Ferrari North America, Inc.

RECALL CAMPAIGN NO. 39
550 Barchetta
"Seat Rail Assemblies"
RECALL CAMPAIGN OVERVIEW

SUBJECT: Recall Campaign No. 39

RECALL CAMPAIGN NO. 39
550 Barchetta
"Seat Rail Assemblies"
Technical Instructions

Seat Rail Kit - Part Number 70000971

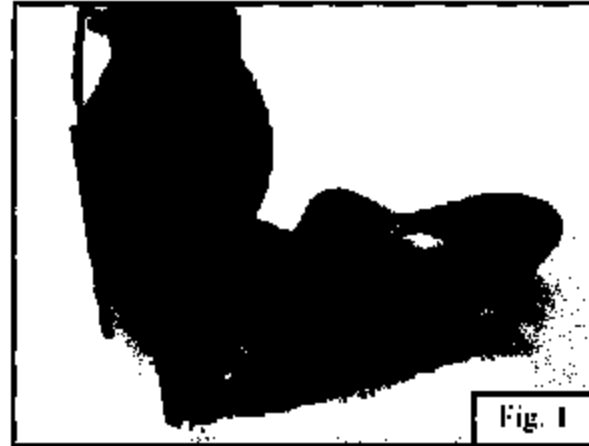
The Parts kit (Part Number 70000971) will consist of the following;

- 4 Seat Rails (Runners)
- 12 Screws M8 x 20
- 8 Split Washers
- 2 Control Levers
- Checking Gauge (Part Num. 95979567)

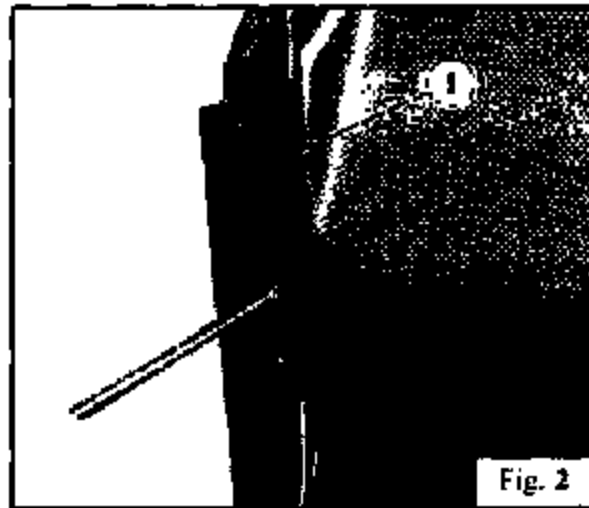
- Remove the seat from the vehicle.
- After having adjusted the seat back with the adjustment knob, so that it is as "closed" as possible, place the seat on a flat surface, after having covered the latter with a cloth in order to avoid damaging the seat's aesthetic features (Fig. 1).

Note: the runners must not be rested on the flat surface, so as not to discharge the seat load on the adjuster.

- Remove the control lever (1) from the runners levering it out with a screwdriver and taking special care for the pins' riveting inside the lever.

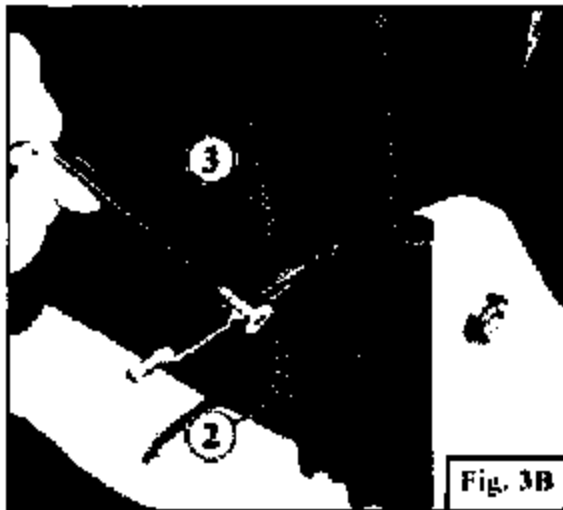
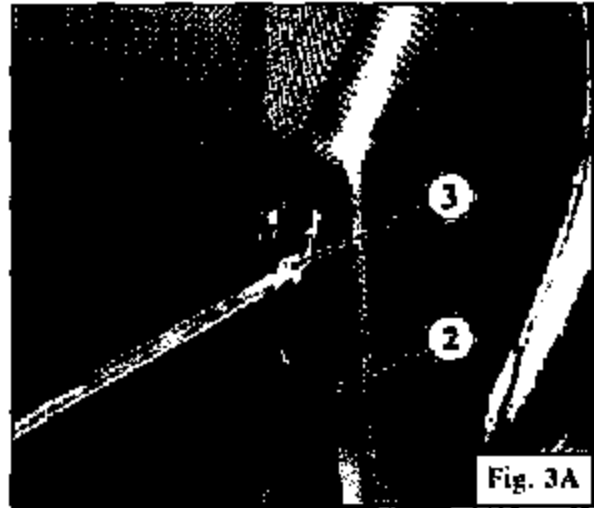
- Remove the runner (2) by undoing the three screws (3) in the reported sequence, taking special care not to move the seat back adjusters. Follow the same procedure to remove the runner on the opposite side.

Fig. 4C

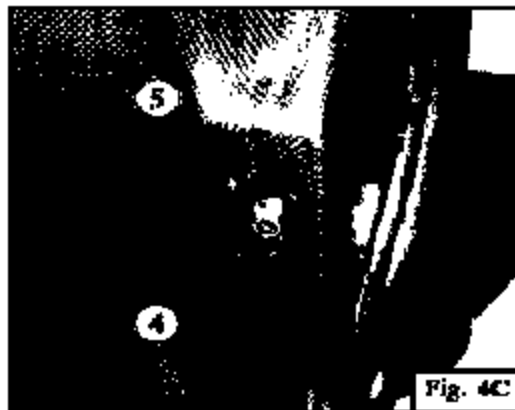
- Apply thread-locking **LOCTITE** on the kit screws **M8X20 (4)**.
- Position the corresponding runner provided with the repair kit and secure it using the three screws **(4)** and the two split washers **(5)**.

Note: the split washers **(5)** must be positioned as shown in the following pictures, to prevent them from interfering with the runner movement.

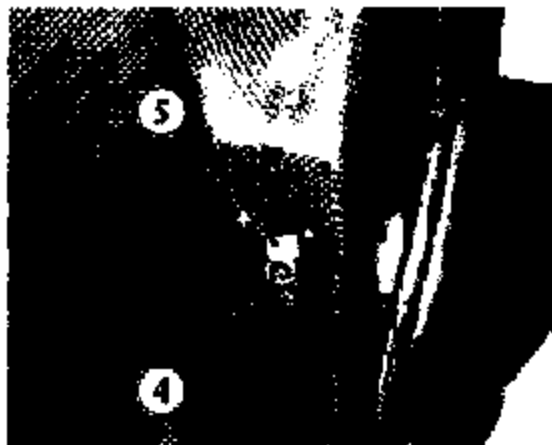
- Slide the runners all the way back, without removing the gauge, then tighten the two upper screws (4) to a torque of 30 Nm.
- Take out the gauge (6) and tighten the two central screws (4) to a torque of 30 Nm.
- Refit the release control lever and then rivet the runner pins inside the tube using a pointed tool.
- Move the sliding parts of the runners all the way forward.
- Using the release lever, position the right-hand and left-hand bolts in their natural seats: you must hear them click in place on both sides.
- Position the seat inside the vehicle.

Note: when positioning the seat in the vehicle, take special care not to lift it off of the release lever.

- Screw up the front screws fitting the split washers, Ferrari part no. 63395300 in between, without tightening them.
- Sit on the seat, slide it all the way forward making sure that when it reaches the end-of-travel point the release lever is fully down. You must hear both bolts, positioned in their natural seating, click into place.
- Position the rear screws fitting the split washers, Ferrari part no. 63395300 in between and tightening them to a torque of 29 Nm.
- Tighten the front screws to a torque of 29 Nm.
- Move the seat to check it runs smoothly.
- When refitting the driver's seat, reconnect the plug for the seat belt fastening sensor.
